UNITED STATES
NUCLEAR REGULATORY COMMISSION
WASHINGTON, D.C. 20555-0001

SUBJECT: WATERFORD STEAM ELECTRIC STATION, UNIT 3 – FLOOD FOCUSED
EVALUATION ASSESSMENT (CAC NO. MF9710; EPID L-2017-JLD-0009)

STAFF ASSESSMENT BY THE OFFICE OF NUCLEAR REACTOR REGULATION
RELATED TO THE FOCUSED EVALUATION FOR
WATERFORD STEAM ELECTRIC STATION, UNIT 3
AS A RESULT OF THE REEVALUATED FLOODING HAZARD NEAR-TERM TASK FORCE
RECOMMENDATION 2.1- FLOODING
CAC NO. MF9710

Figure 3.0-1 – General Layout of Waterford Site (adapted from Figure 3-3 of July 21, 2015, FHRR (ADAMS Accession No. ML15204A321))

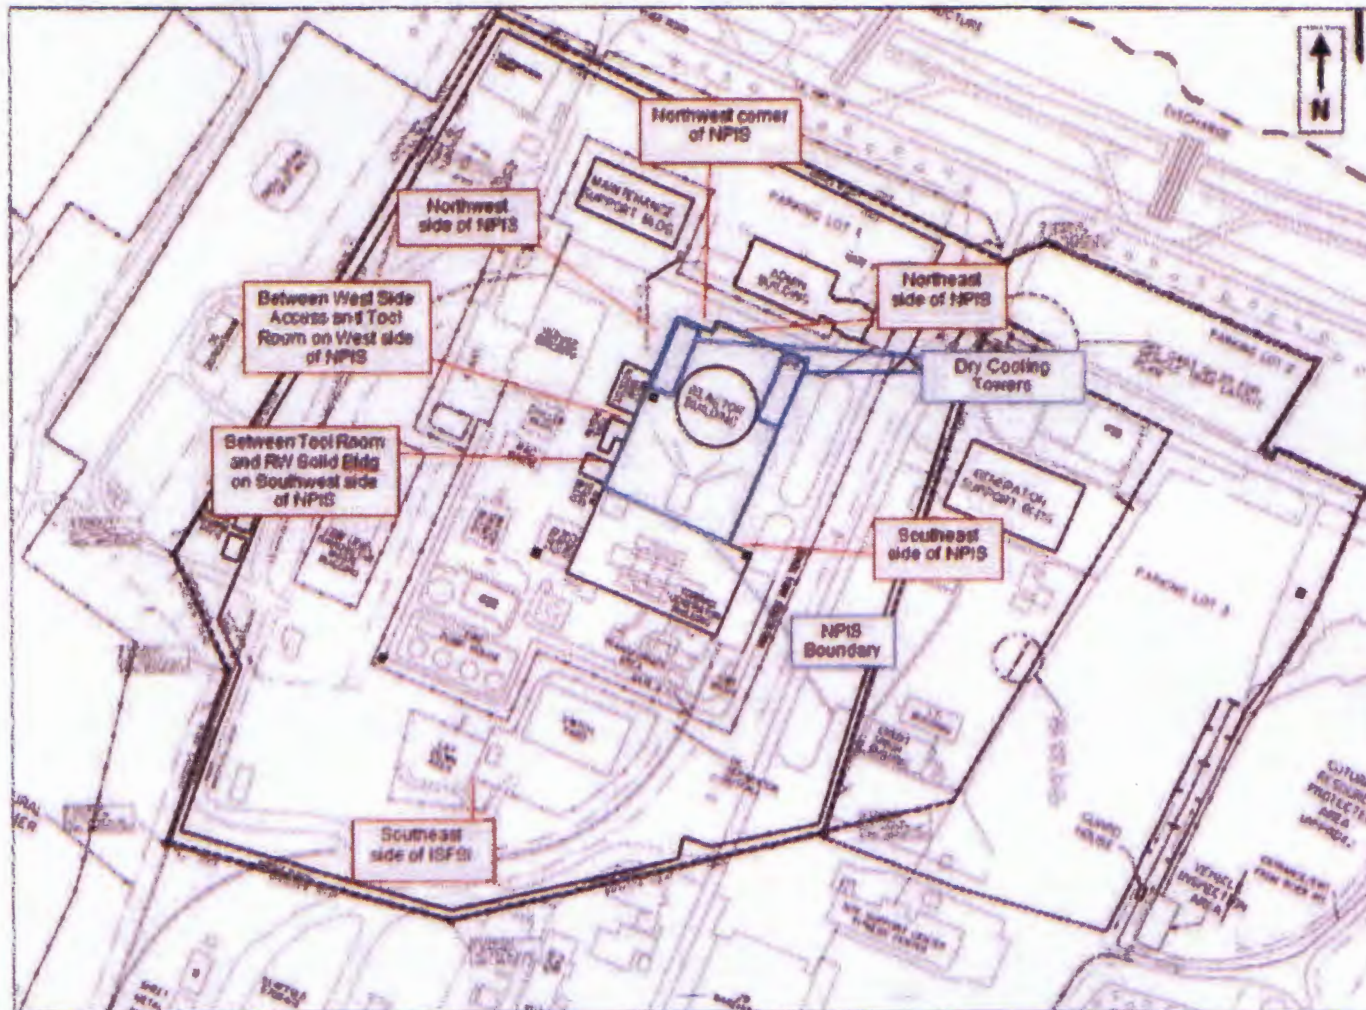
Per Waterford's CDB, the structures, systems and components (SSCs) important to safety are flood protected because they are enclosed in a rectangular box-like reinforced concrete structure 380 feet (ft.) long, 267 ft. wide, and extending 64.5 ft. below grade known as the nuclear plant island structure (NPIS). The NPIS is the common structure of the reactor containment building (RCB), reactor auxiliary building (RAB) and the Fuel Handling Building (FHB). All seismic Category I structures, safety-related systems and components are housed in the NPIS. All exterior doors and penetrations which lead to areas containing safety-related equipment are watertight up to 29.18 ft. mean sea level (MSL). Figure 3.0-1 of this document provides a general overview of the site including an outline of the NPIS.

Figure 3.0-2 Overview of the Location of the "B" Wet and Dry Cooling Towers

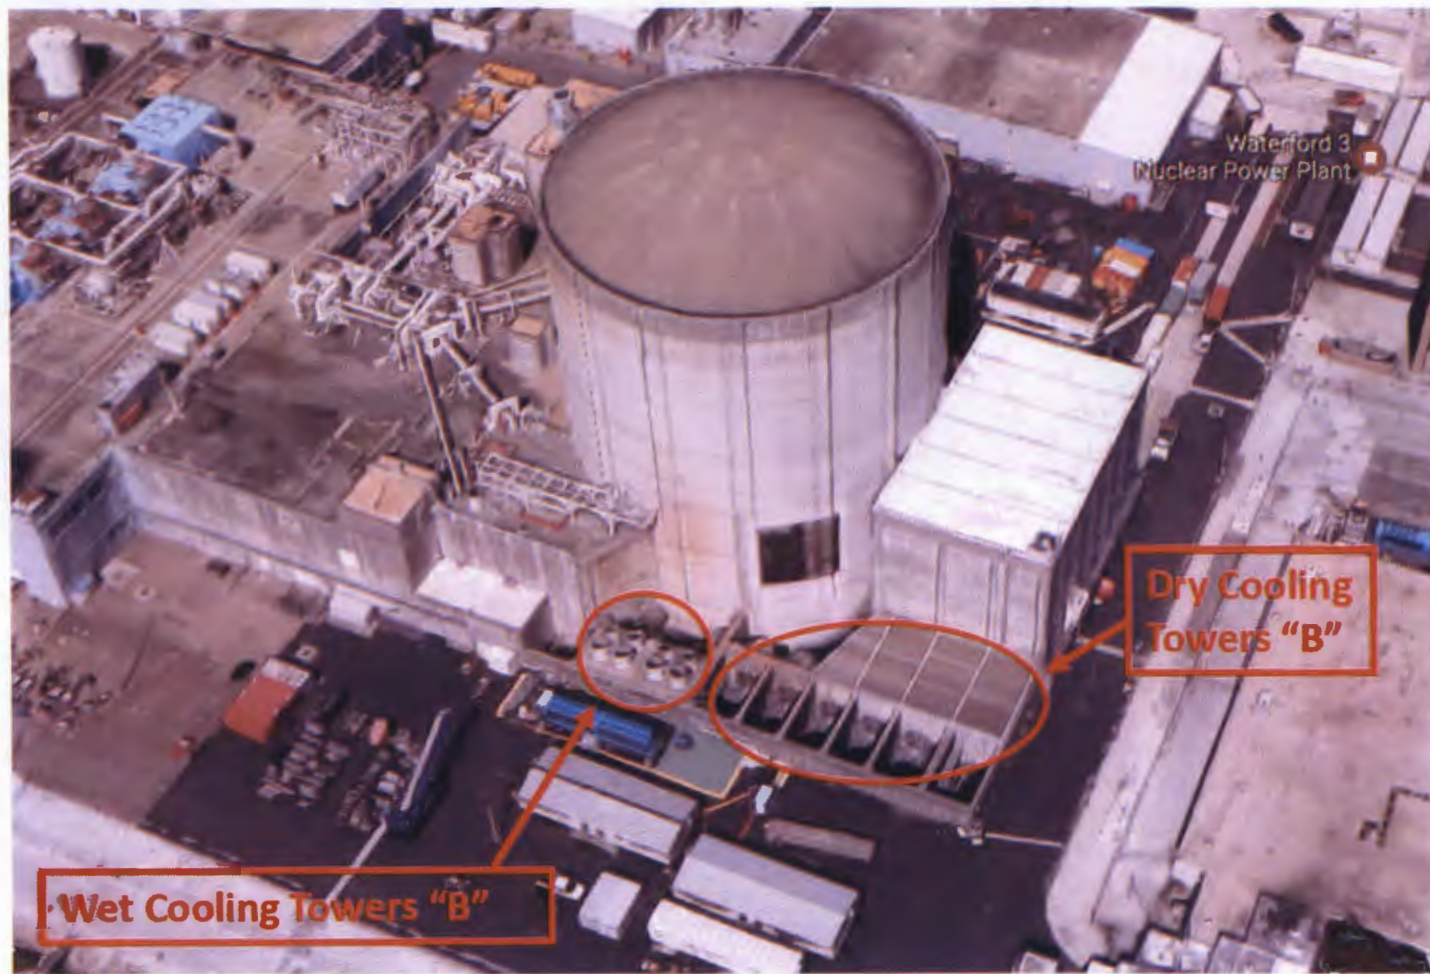
The auxiliary component cooling water system (ACCWS) removes heat, if required, from the CCWS via the component cooling water heat exchangers and dissipates it to the atmosphere. The ACCWS consists of two independent loops which include two CCWS heat exchangers (shell side); two full-capacity pumps; two wet type, mechanical draft cooling towers; and two cooling tower basins, each of which stores sufficient water to complete a safe shutdown based upon a loss of coolant accident and minimum safeguards operation. Figure 3.0-2 of this document provides an overview of the location of the "B" wet and dry cooling towers, which are both located within the NPIS.

Figure 3.2-1 – Location of the Bonnet Carre Spillway and Floodway in Relation to the Waterford Site (adapted from Figure 3-23 of the July 21, 2015, FHRR (ADAMS Accession No. ML15204A321))

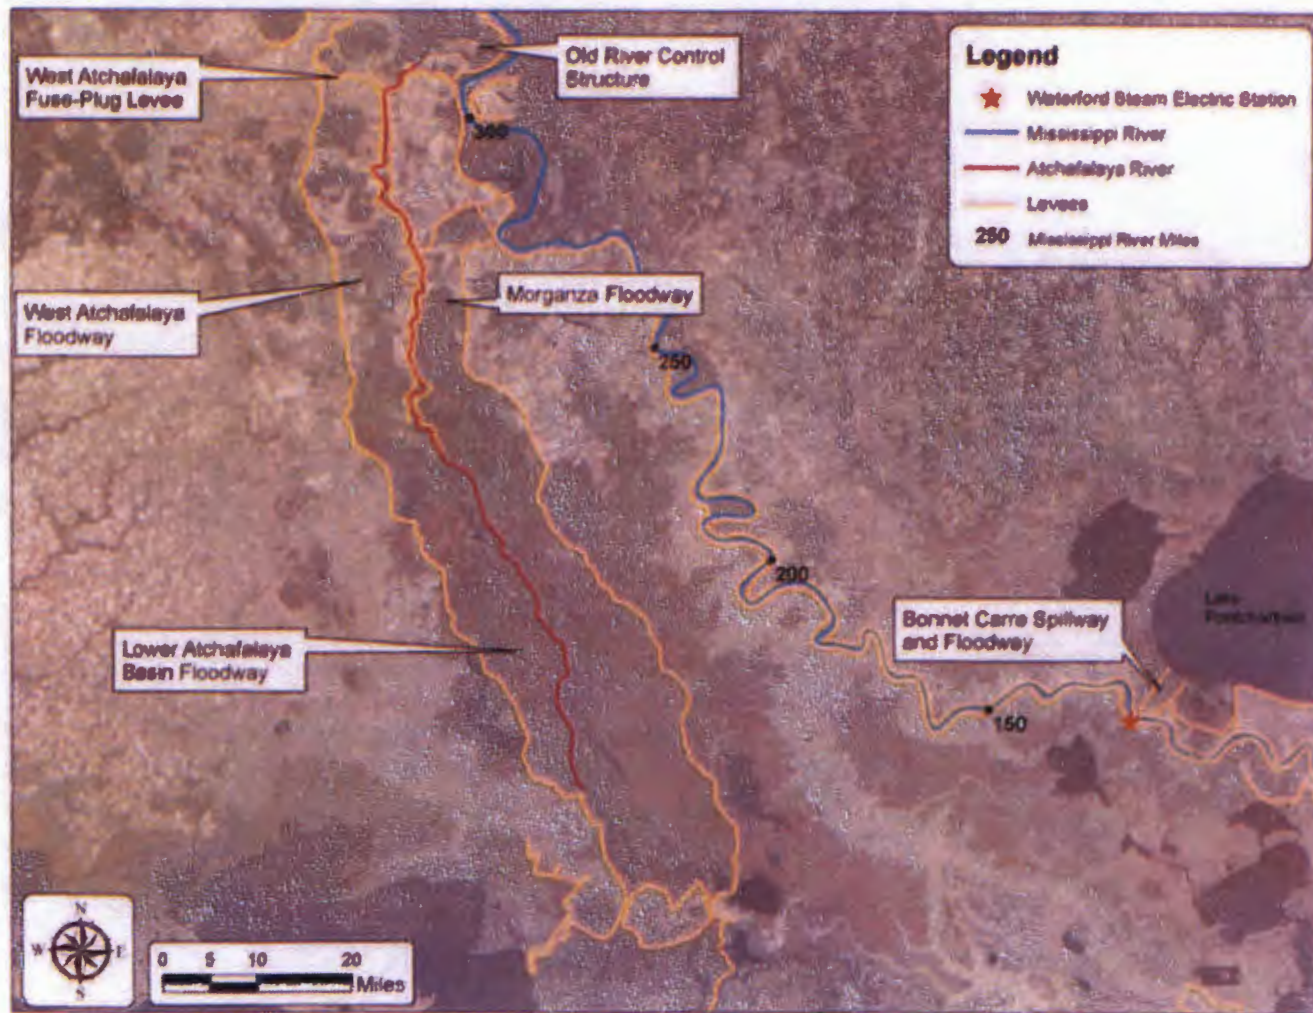
- As described in Section 3.2.2 of its FHRR, the licensee's evaluation did not credit the Bonnett Carre Spillway and Floodway that could be used to divert flow from the Mississippi River to Lake Pontchartrain) was not modeled. Figure 3.2-1 shows the location of this spillway in relation to Waterford. Allowing water to be diverted via this spillway to Lake Pontchartrain would lower the PMF water surface elevation at Waterford. The staff agrees with the licensee's assertion that it is a conservative assumption to not model this spillway.
